## **Burlington Design Advisory Board**

### **DESIGN ADVISORY BOARD Tuesday October 27, 2020 3:00 PM REMOTE MEETING**

**To:** The Design Advisory Board  
**From:** Mary O'Neil, AICP, Principal Planner  
**RE:** ZP21-0358CA/CU; 40 Kingsland Terrace  
**Date:** October 27, 2020

**To:** The Design Advisory Board  
**From:** Mary O'Neil, AICP, Principal Planner  
**RE:** 323-325 College Street  
**Date:** October 13, 2020

# Layout and Materials Plan

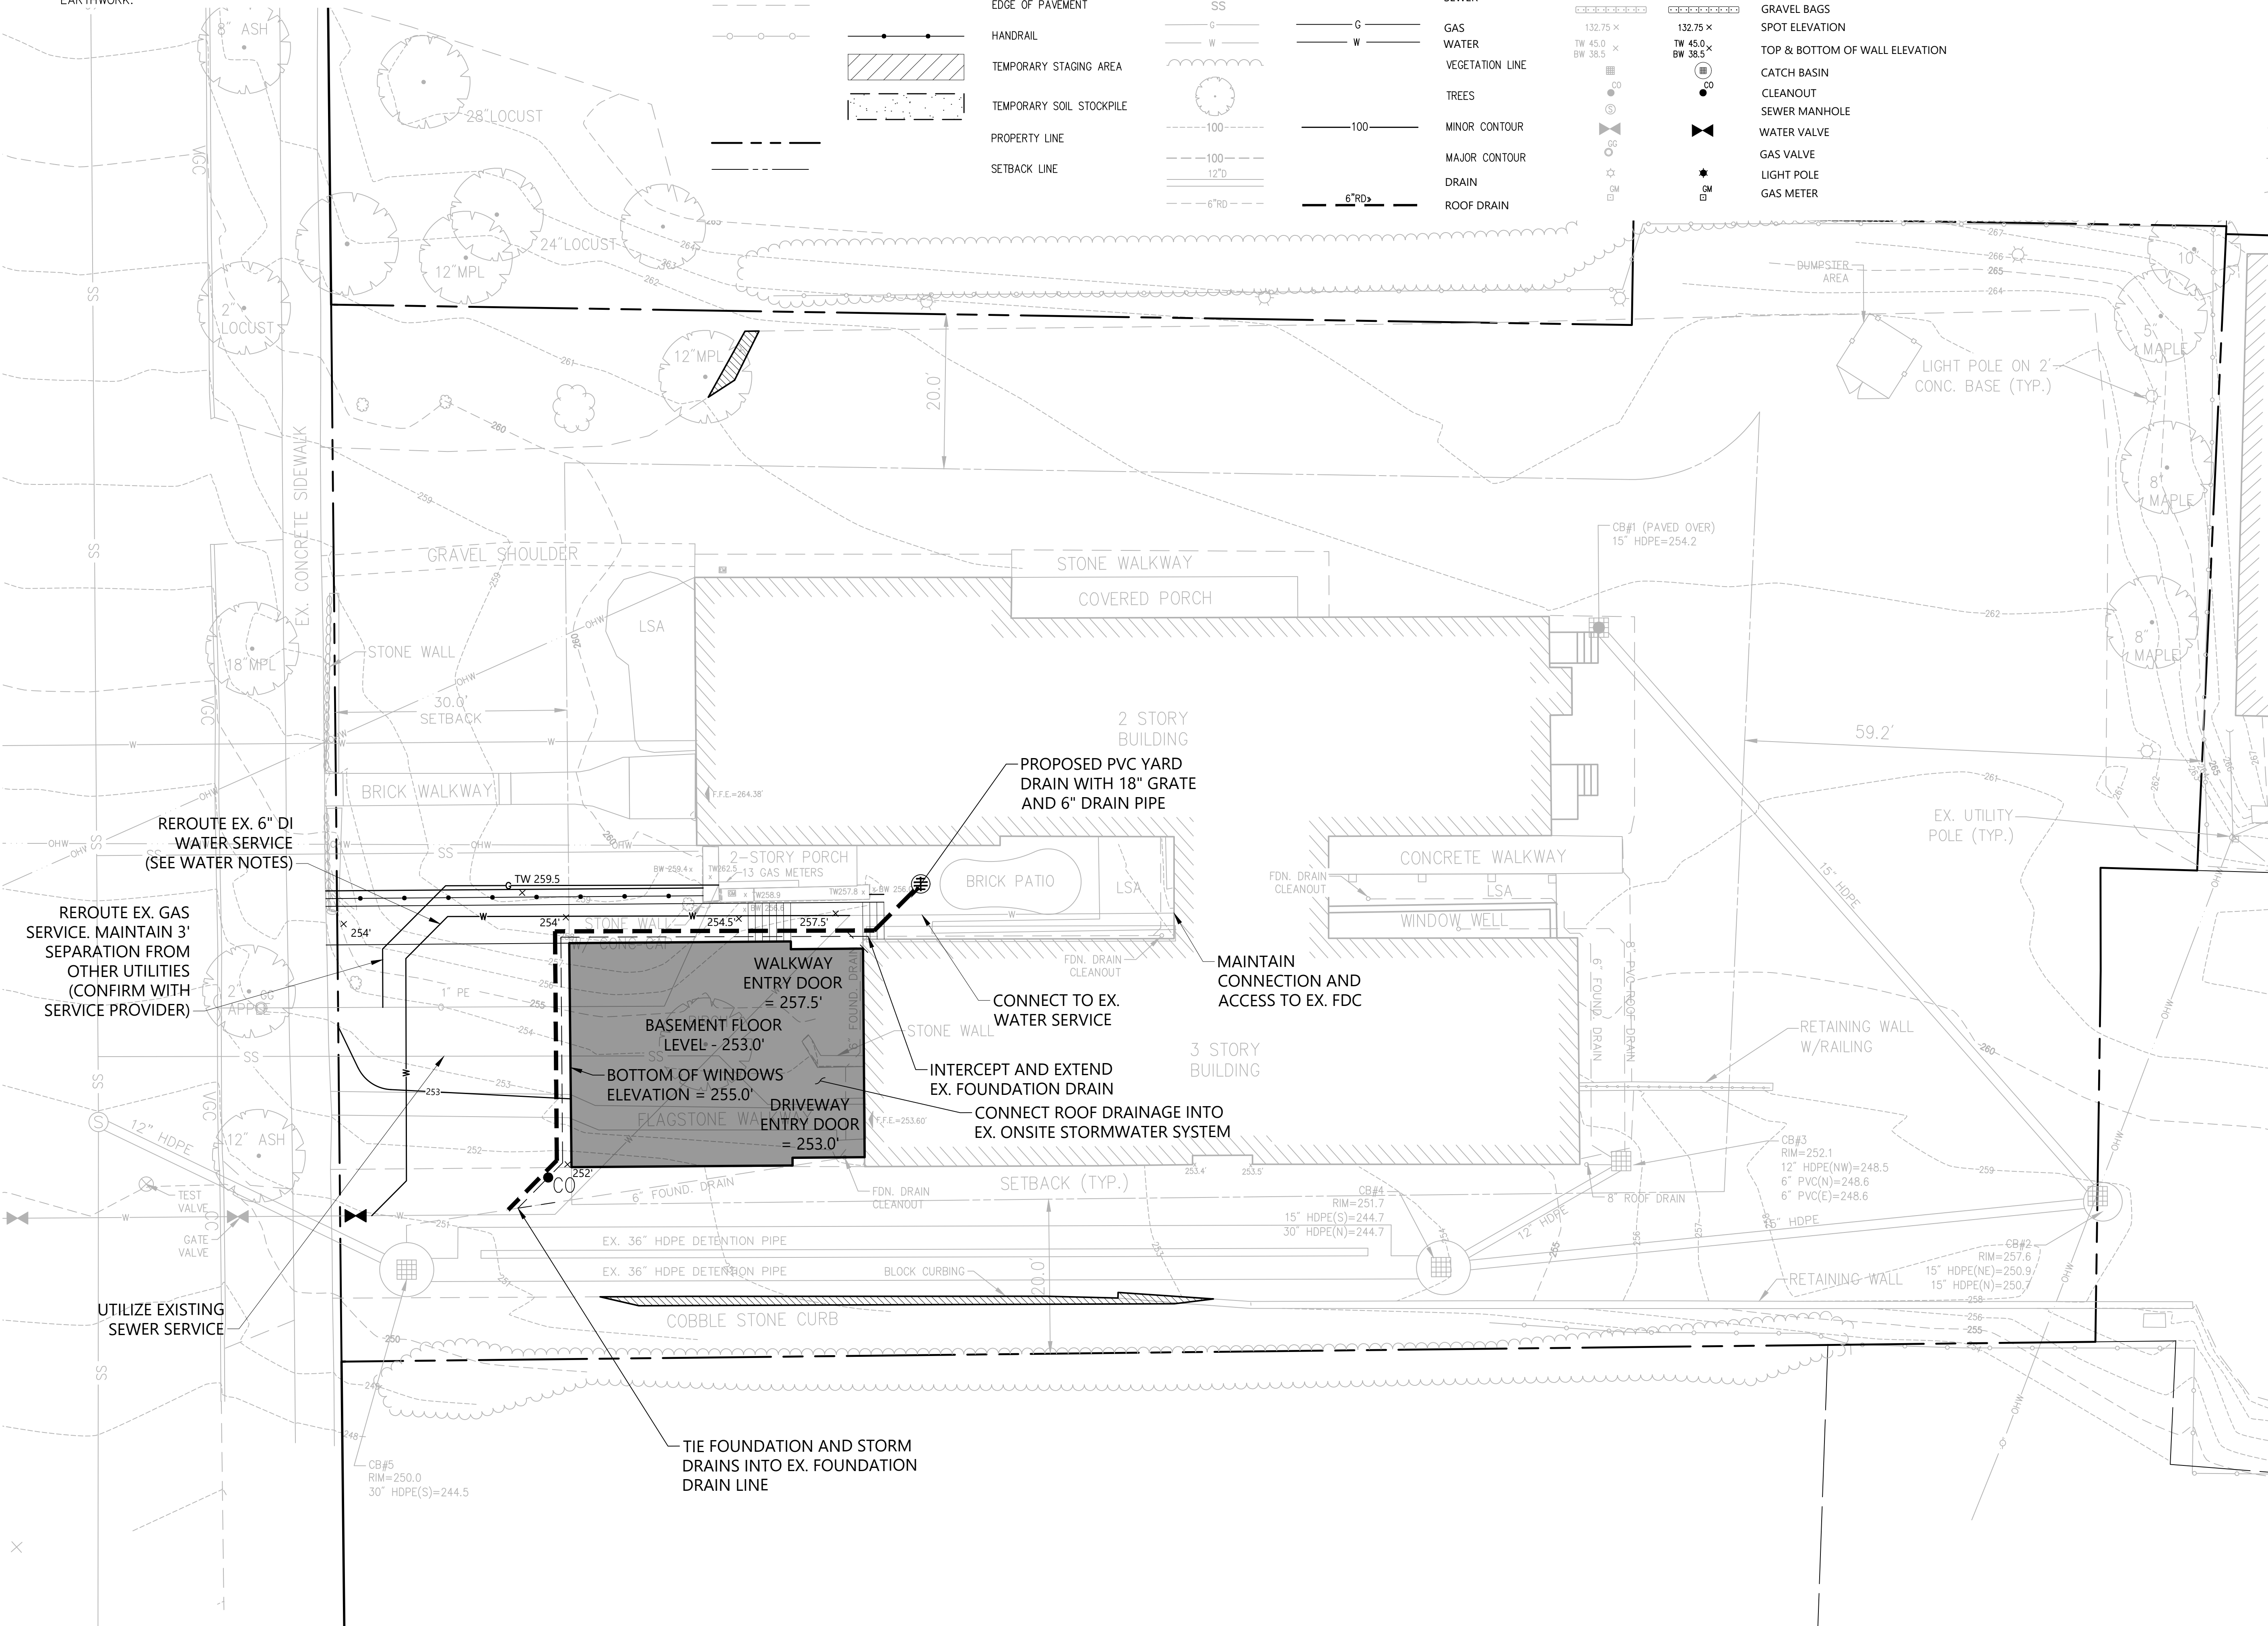
A 5' wide walkway is illustrated from the public sidewalk on College Street to the new easterly entrance to the addition (Plan C1.01.) The westerly entrance immediately abuts the new parallel parking spaces. The area (9.3' in width) should be appropriately marked as a pedestrian entry, clearly marked by differentiated ground materials and/or pavement markings.

The last permit approved 34 parking spaces on-site for the 13 units. (18-0977LL, 19-0203CA.) 41 parking spaces are proposed with this site plan, reflecting the addition of 6 new parallel parking space on the west of the addition. The location of the additional space has not been identified. (34+6=40; 41 identified on C1.01.)

The applicant needs to define any changes to the landscaping, including tree removal with the proposed new addition. Plan C1.01 illustrates a retaining wall with a railing. More information will be required for review. Any retaining wall over 3' requires approval of the City engineer.

7. The applicant shall provide further information about the new retaining wall and the fence, as well as more definition about what "adjust retaining wall" means. (Plan C1.01)

8. The applicants shall provide an updated snow management plan.
9. The westerly pedestrian entrance shall be clearly marked by differentiated ground materials and/or pavement markings to prevent vehicular blockage of the building entrance.

10 LEVEL 2 FLOOR PLAN

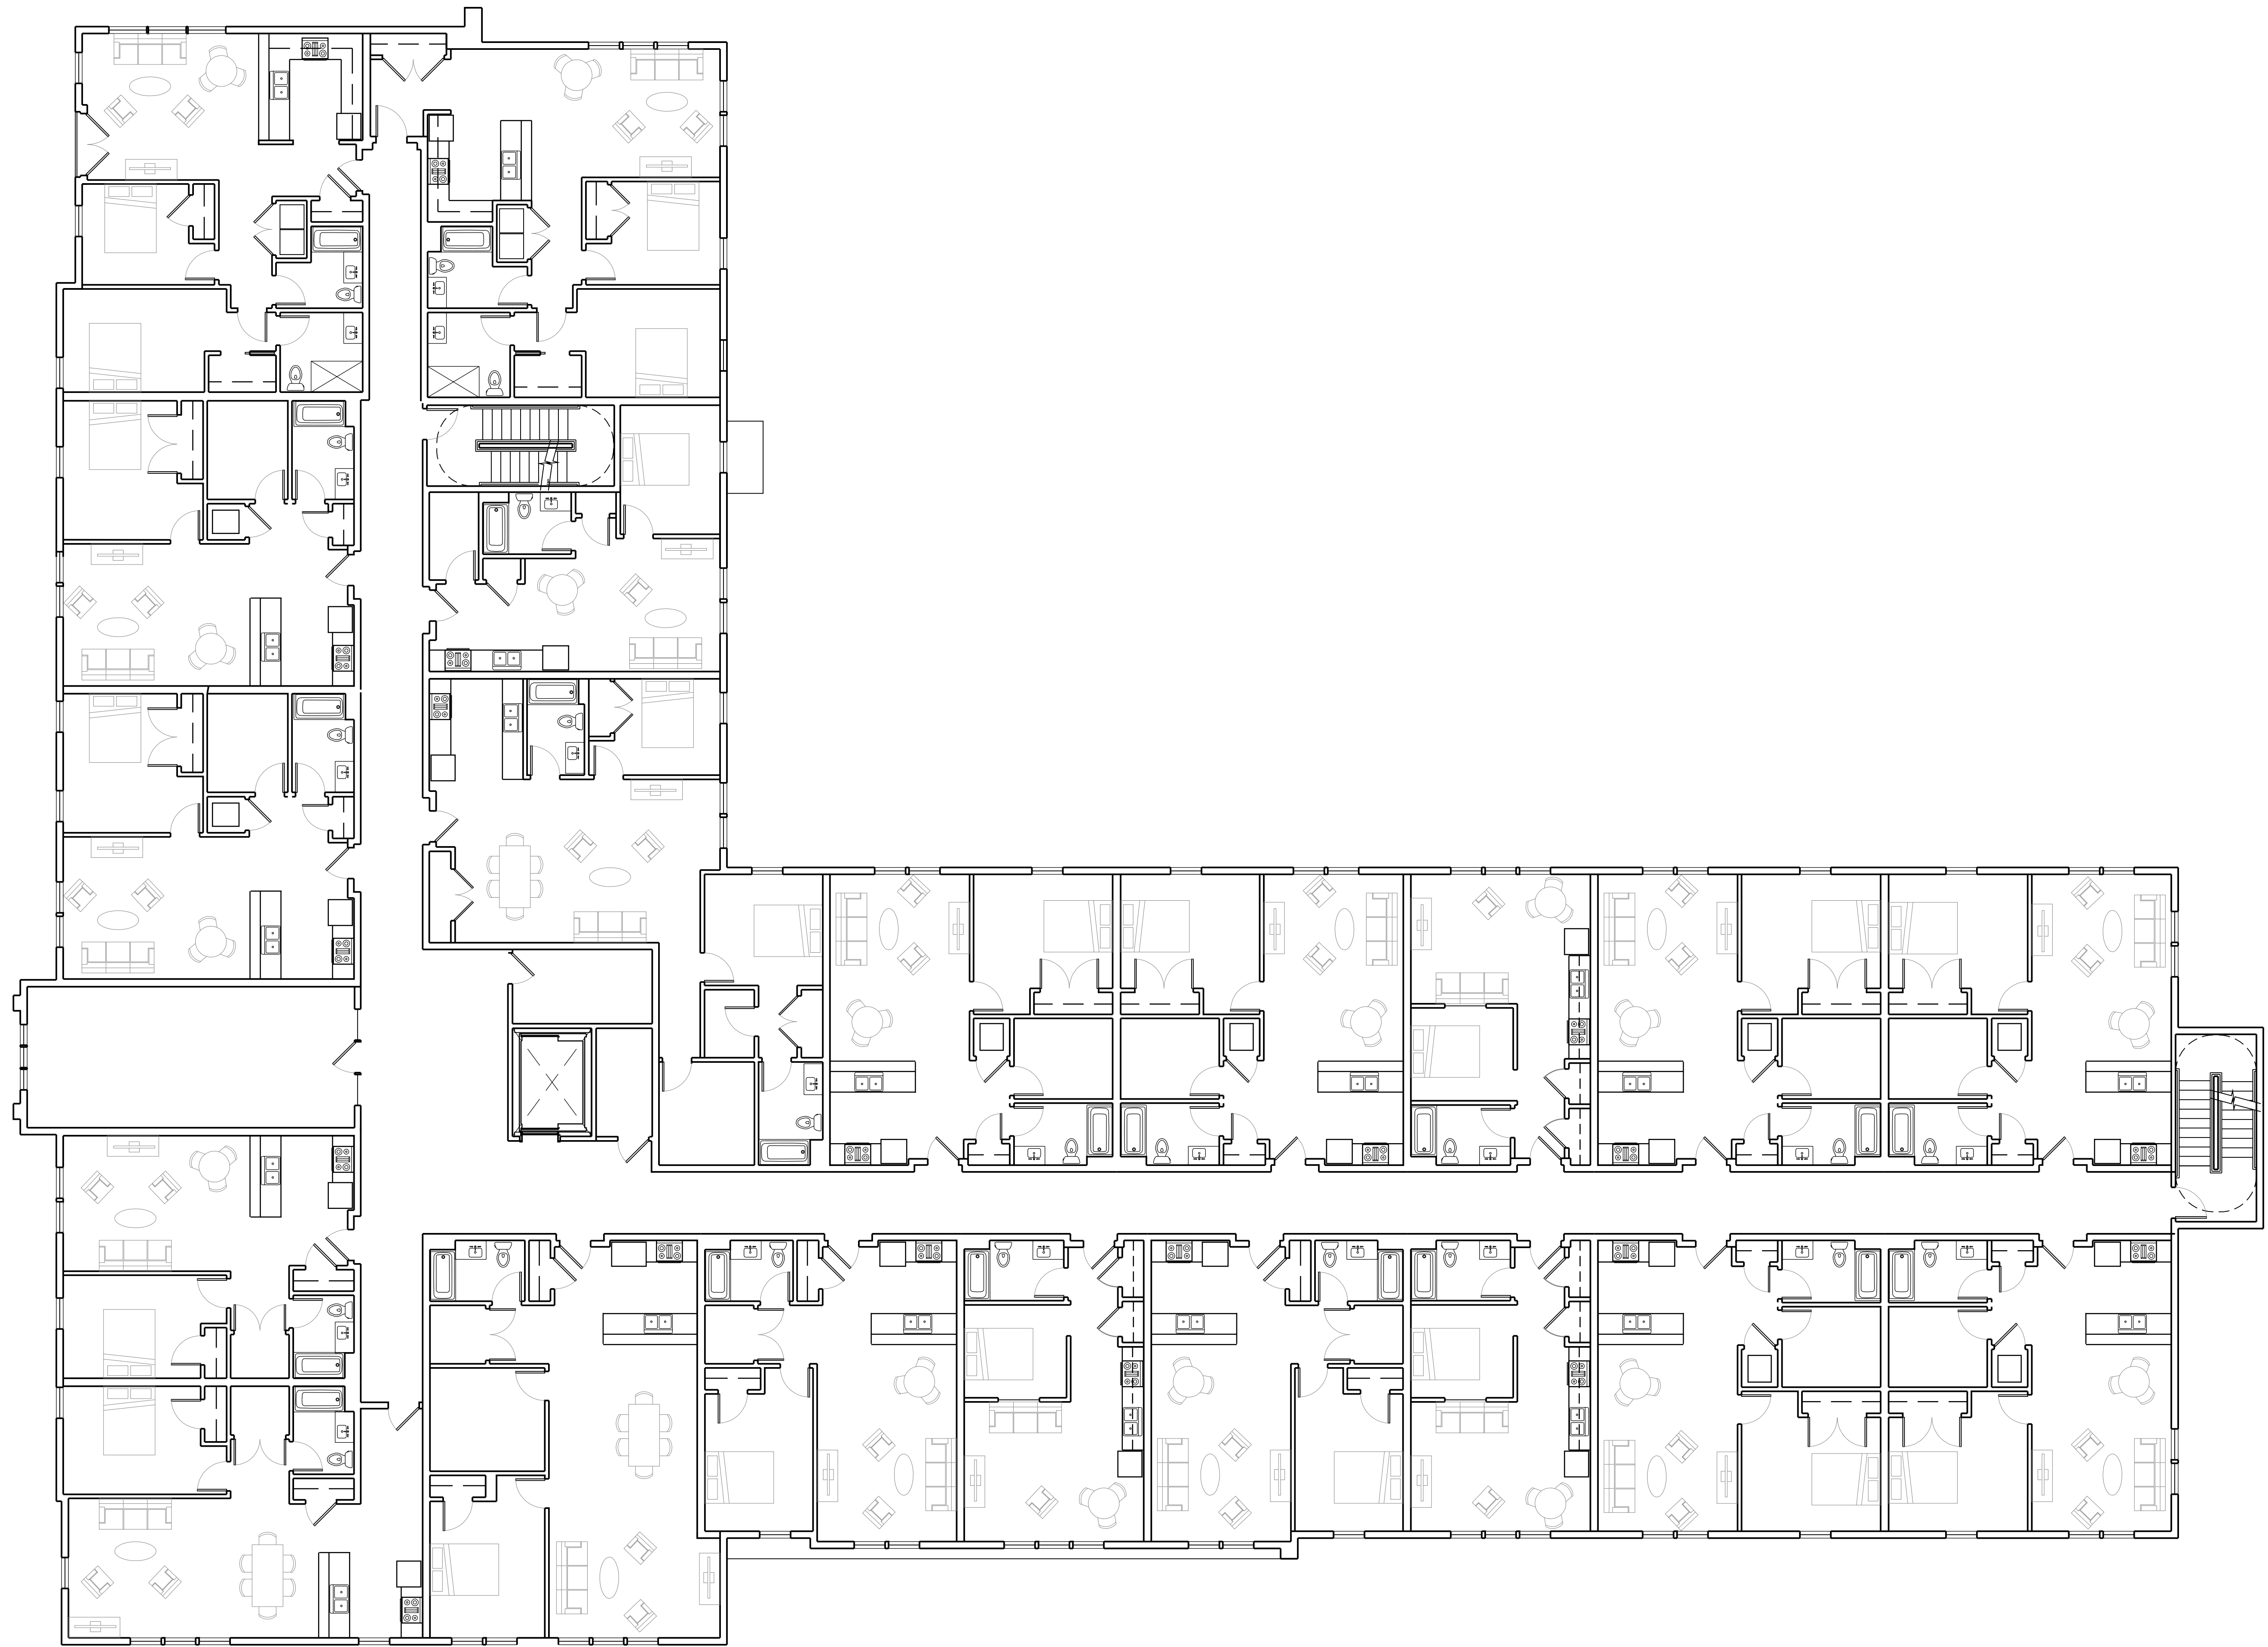
Interior mechanical space is depicted on the floor plans. See Plan A102. Electrical service connection is not evident on the utility plan. Power lines serving the building must be buried and utility boxes must be screened.
